SERVICE LETTER NO. 78
FEBRUARY 1, 1951

SUBJECT: FUEL SYSTEM ACCUMULATOR TANK MAINTENANCE AND MODIFICATION

SUBJECT	Fuel Accumulator Tank - Replacement
EFFECTIVITY	All Navions
DRAWING	Tanks experienced corroding Item # 2307 P/N 145-48004 Replacement tanks - Item # 2307-10 P/N 145-48006

Figure 1 - Accumulator Tank Bracket

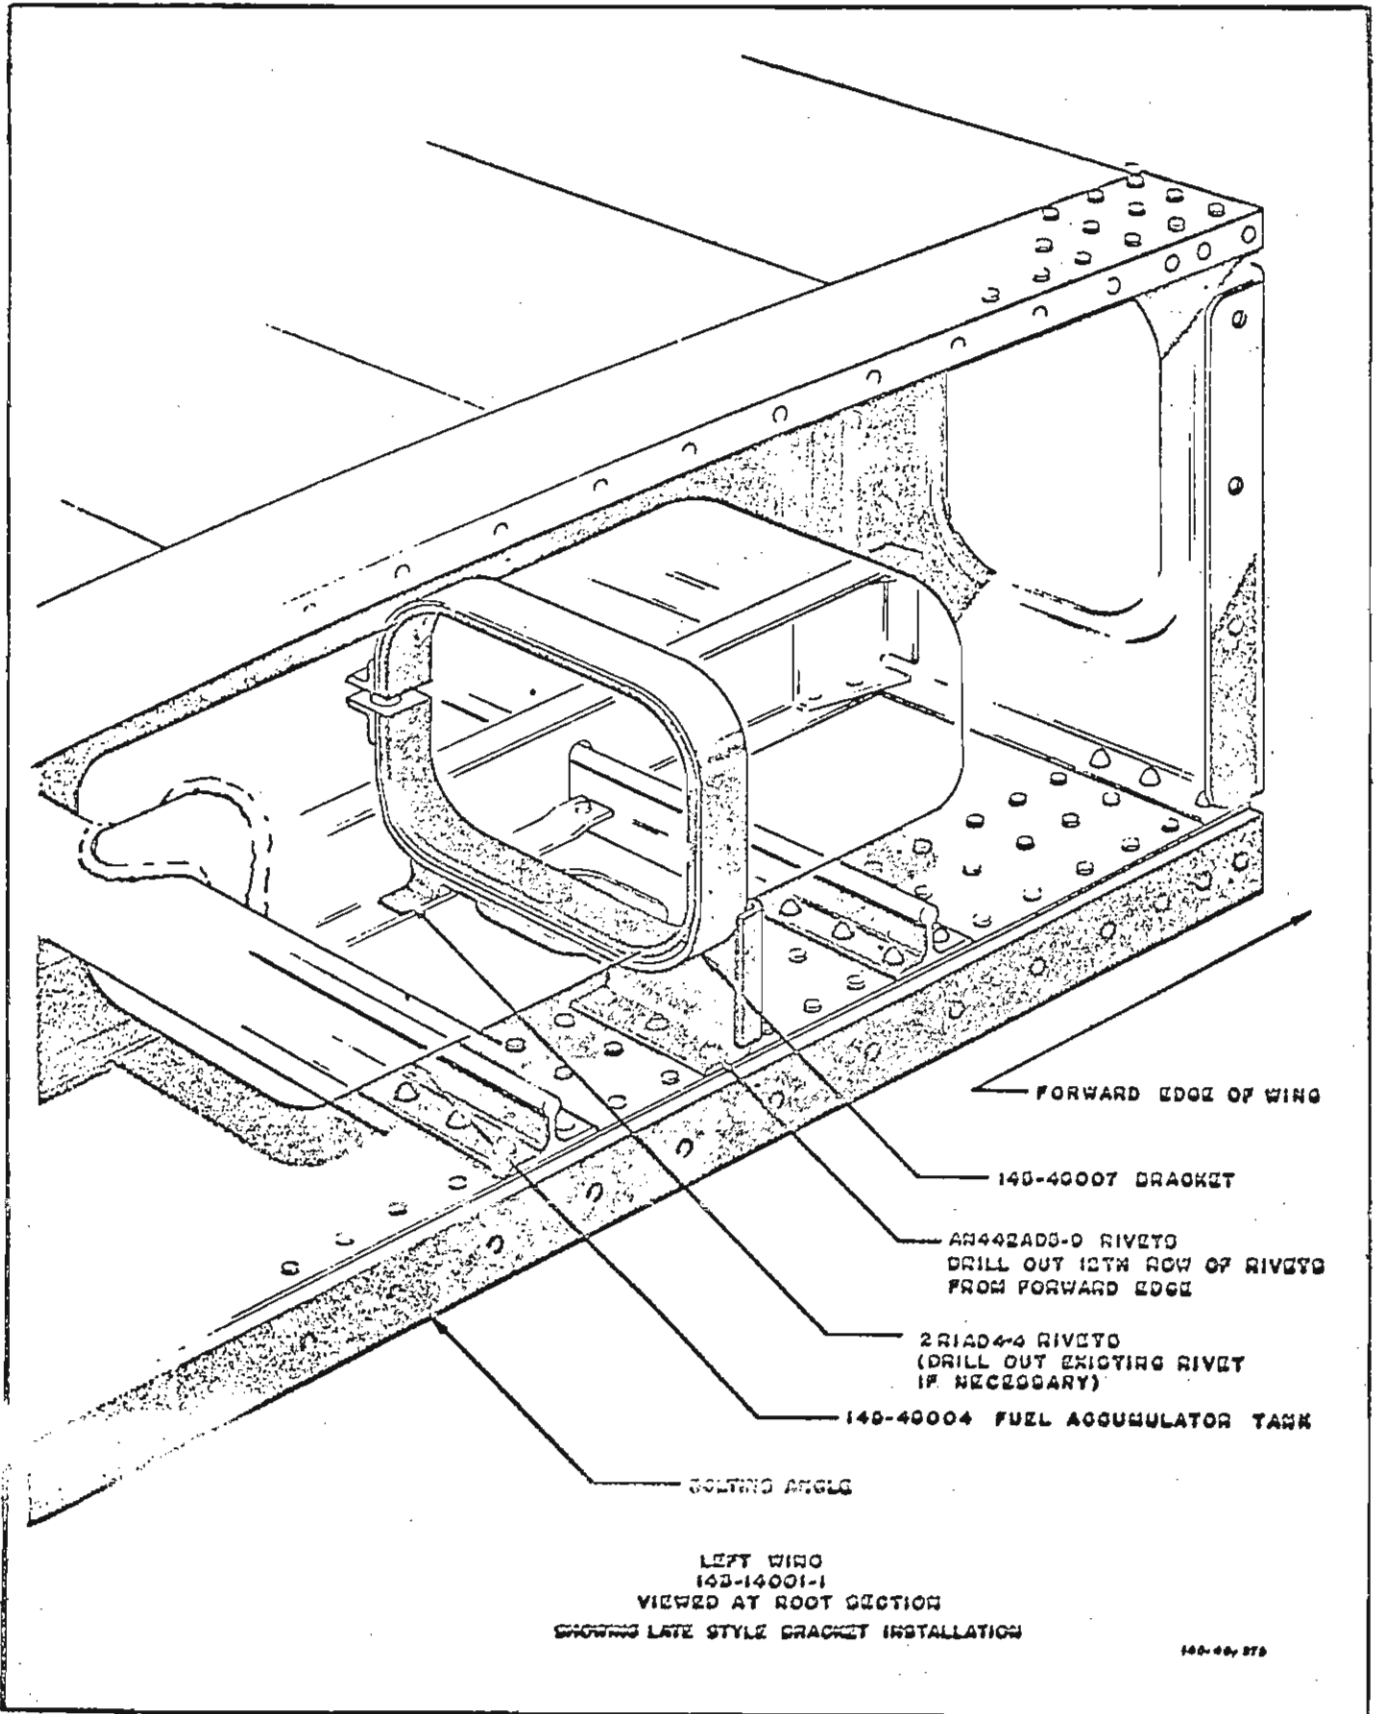
Navion airplanes prior to factory serial number NAV-4-1251 have the fuel accumulator tank supported by two 145-48008 brackets riveted to the 143-14010-20 center rib. Airplanes subsequent to NAV-4-1251 have the fuel accumulator tank supported by one 145-48007 bracket, riveted to the bolting angle of the left wing.

1. Inspect inside the root section to see if fuel accumulator tank bracket 145-48007 is installed. If the 145-48007 bracket is installed, remove it from the wing as follows:
 - a. Drill out the three AN442AD5-9 rivets which attach one end of 145-48007 bracket to the wing bolting angle. This is the 12th row of rivets aft of forward edge of the wing.

- b. Drill out one 2R1AD4-4 rivet attaching the outboard end of the 145-48007 bracket, and remove bracket from wing.
- c. Replace the first three removed rivets with AN442AD5-8 rivets. Replace the removed outboard rivet with one 2R1AD4-3 rivet.

1. Inspect the inside root section of left wing to see if the 145-48007 fuel accumulator tank bracket is installed. If bracket is not present, install the new 145-48007 bracket, received as a loose part, as follows:
 - a. Drill out three AN442AD5-8 rivets which run spanwise in the bolting angle. This is the 12th row of rivets aft of the forward edge of wing.
 - b. Clamp 145-48007 bracket in the wing with the flange of bracket over holes just drilled. Drill through bolting angle holes and bracket flange with a No. 21 (.159) drill.

CAUTION: Do not elongate holes in bolting angle.
 - c. Attach bracket to bolt angle with three AN442AD5-9 rivets.
 - d. Drill through rib, wing skin, and pilot hole on outboard flange of bracket with No. 30 (.128) drill, and install one 2R1AD4-4 rivet.
